Proposal for amendments to UN Regulation No. 58

The text reproduced below was prepared by the experts from CLCCR (International Association of the Body and Trailer Building Industry), to propose amendments to UN Regulation No. 58. The modifications to the current text of UN Regulation No. 58.02 are marked in bold for new or strikethrough for deleted characters.

Figure 1

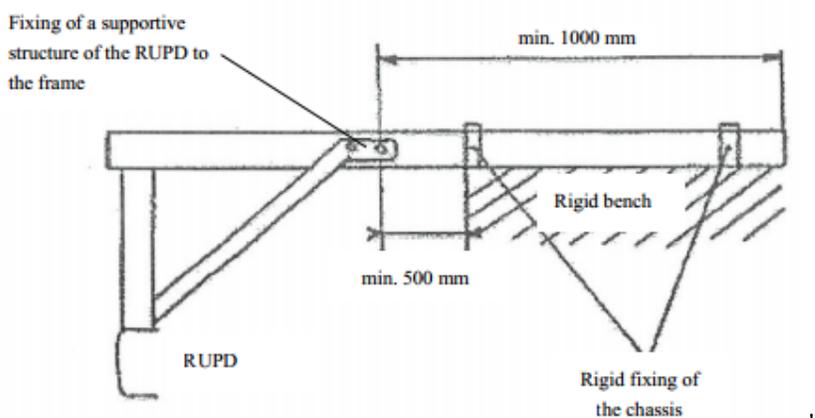
"1.1.3. On a rigid test bench **using side rails representative of the chassis of vehicles for which the underrun protection system is intended (see Figure 1, representing the minimum requirements to be fulfilled).**

This paragraph shall be kept in the regulation. In order to account for the differences between possible chassis the paragraph need to be elaborated. Representative side rails shall be used. This paragraph is necessary in order to avoid for specialized component manufacturers manufacturing RUPS to test all different combinations of RUPS, OEM product lines and specific applications. Applying only paragraphs 1.1.1. and 1.1.2 would result in thousands of combinations being tested by each specialized component manufacturer. Allowing only paragraphs 1.1.1. and 1.1.2. will possibly be applicable for OEM (including trailer manufacturers) that manufacture their own dedicated RUPS.
